ADDENDUM No. 4: October 11, 2017

PROJECT: EAST JEFFERSON GENERAL HOSPITAL
CARDIAC CATHETERIZATION LAB C RENOVATION
4200 HOUMA BLVD.
METAIRIE, LOUISIANA 70006

PROJECT NO.: STBA 41197.31

DRAWING SHEET A802

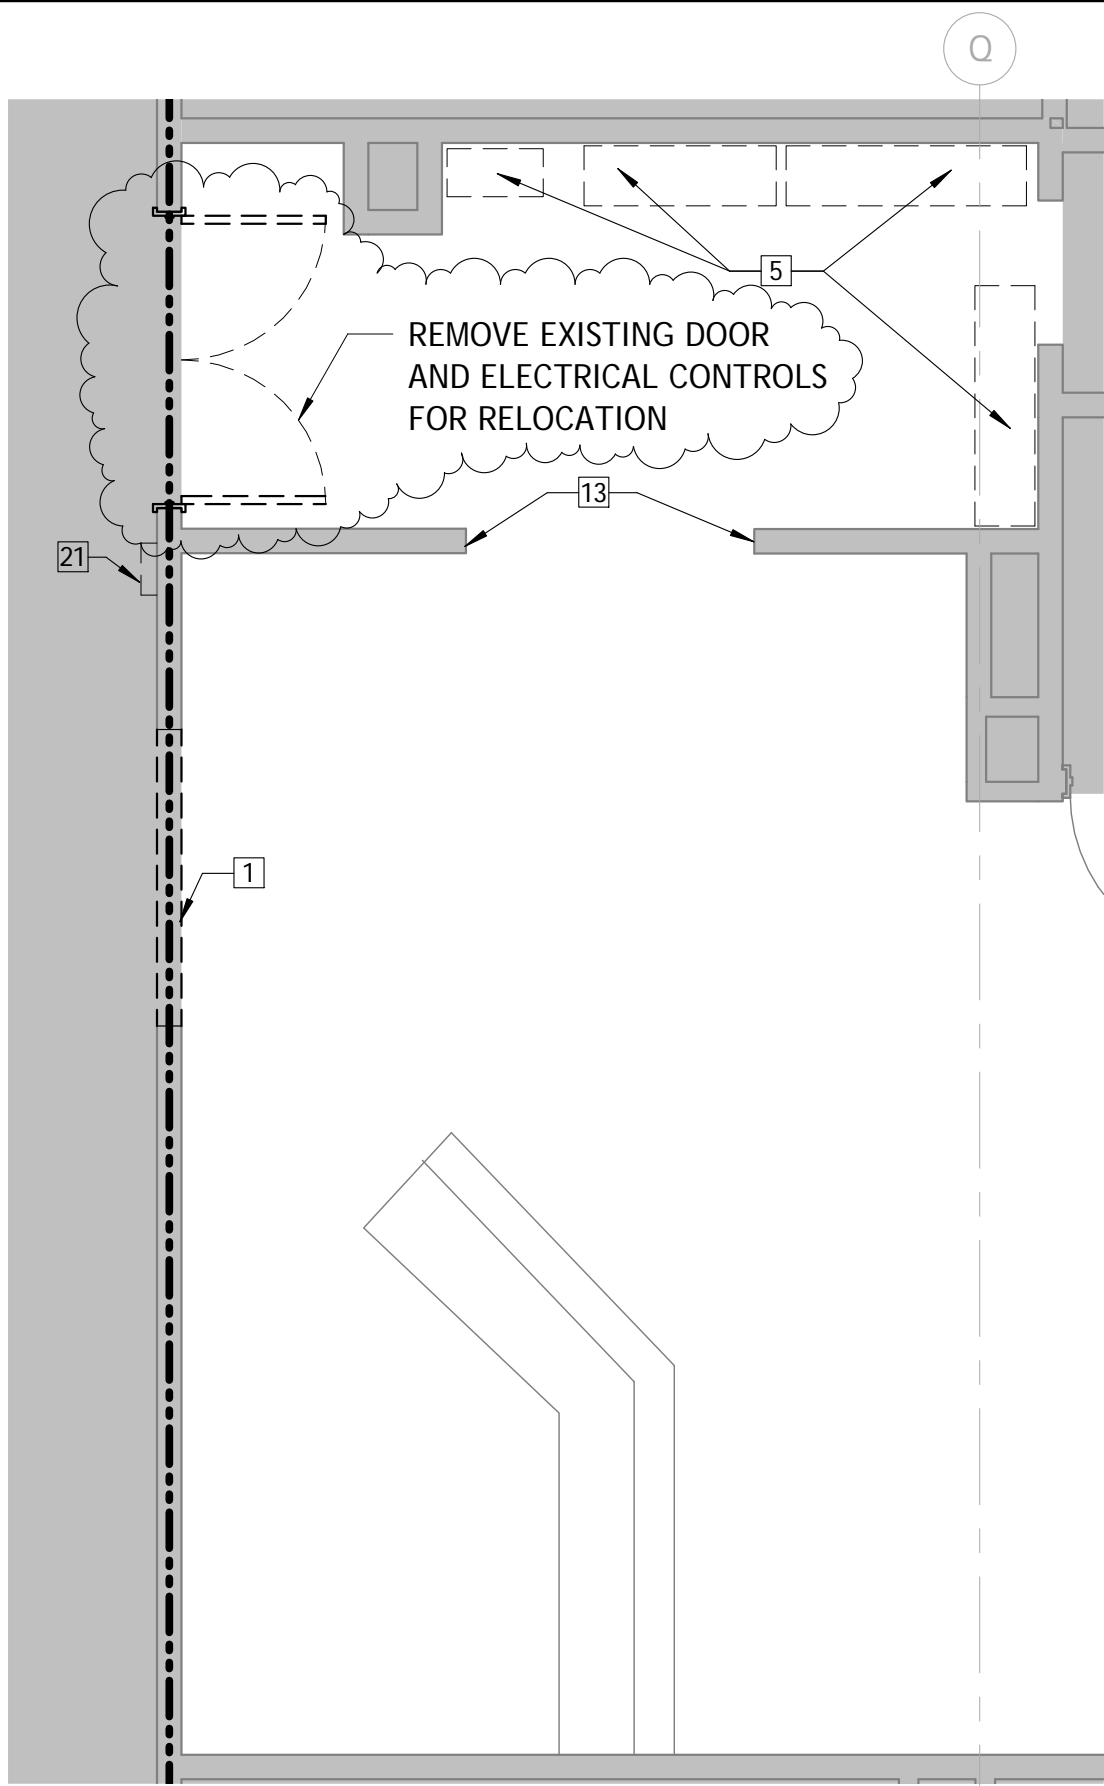
26. ADD, at detail 2/A802, WP-1 from inside corner to inside corner and from the top of the wall base to the underside of the upper cabinets.

project no.	41197.31	date	10/11/17	drawing number	ASK-03
file name	.rvt	issued for	ADDENDUM 04	this drawing modifies:	A201/D201

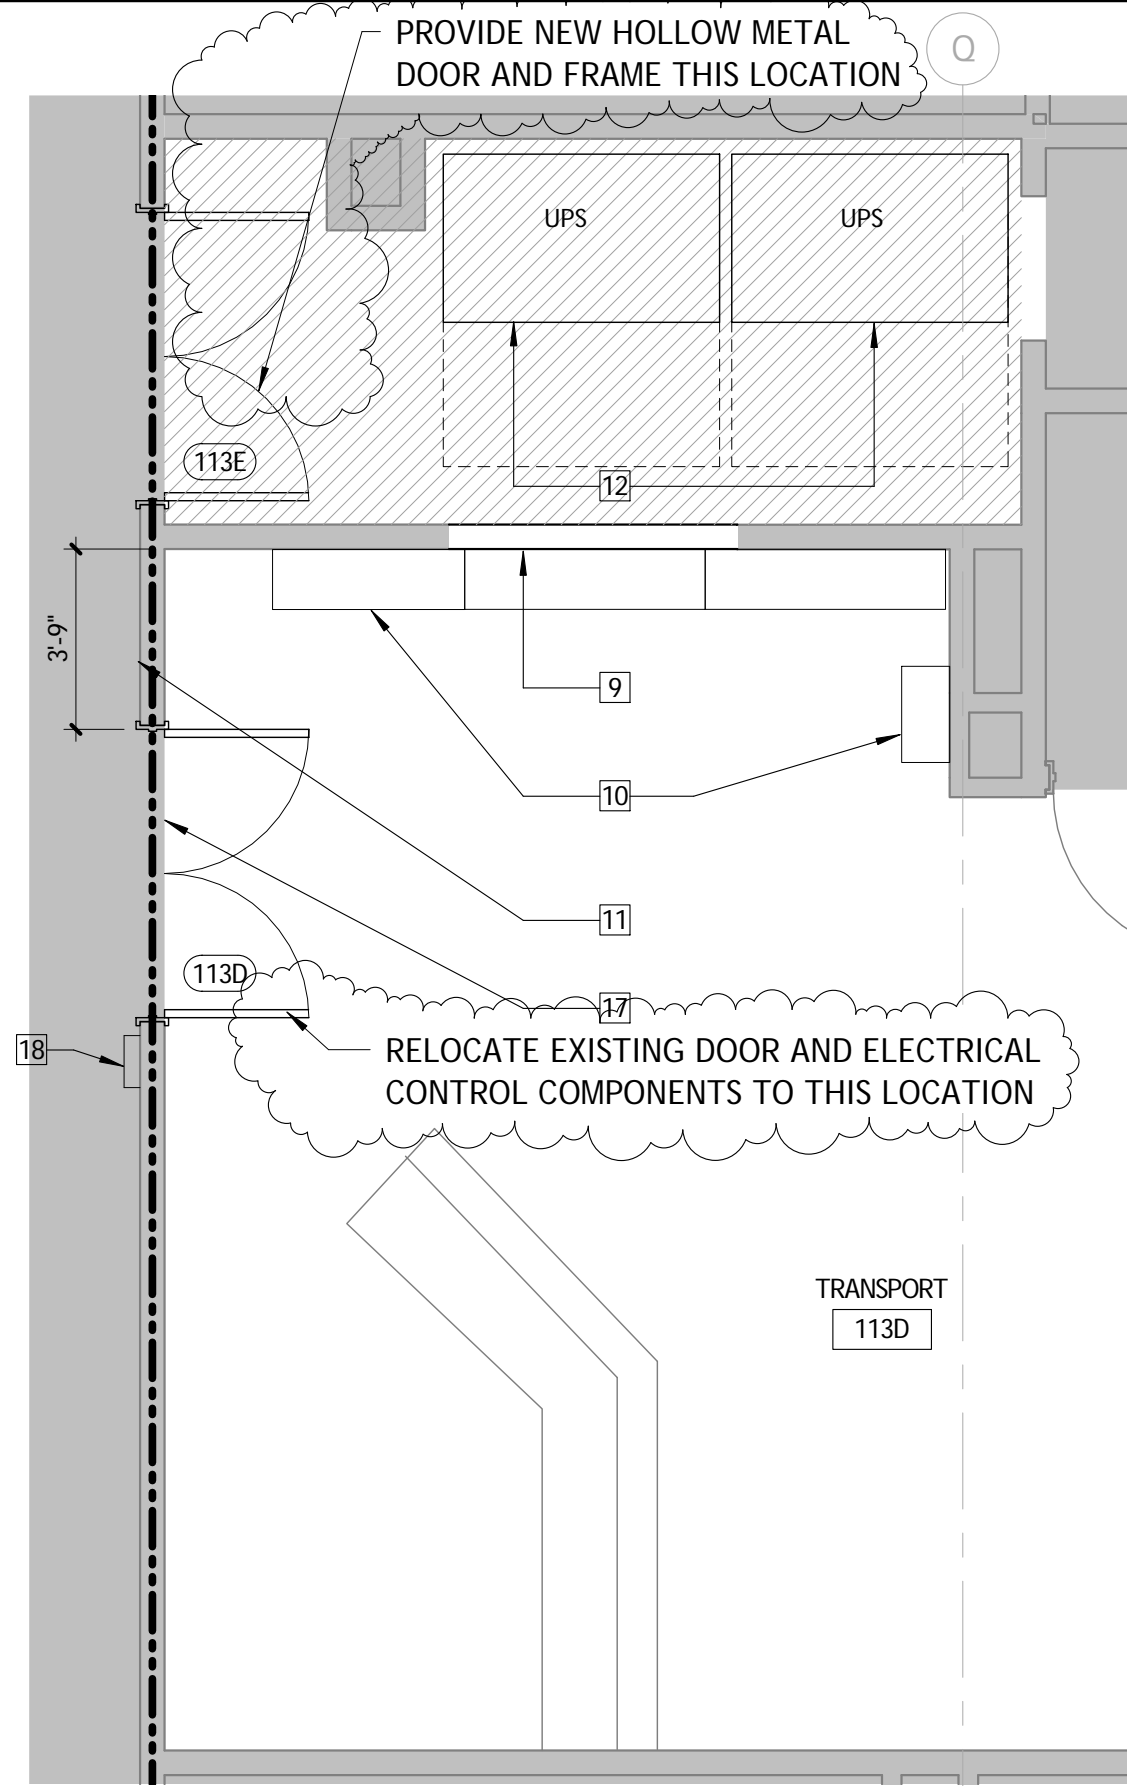
22. CHANGE per attached Sketch.

23. CHANGE per attached Sketch.
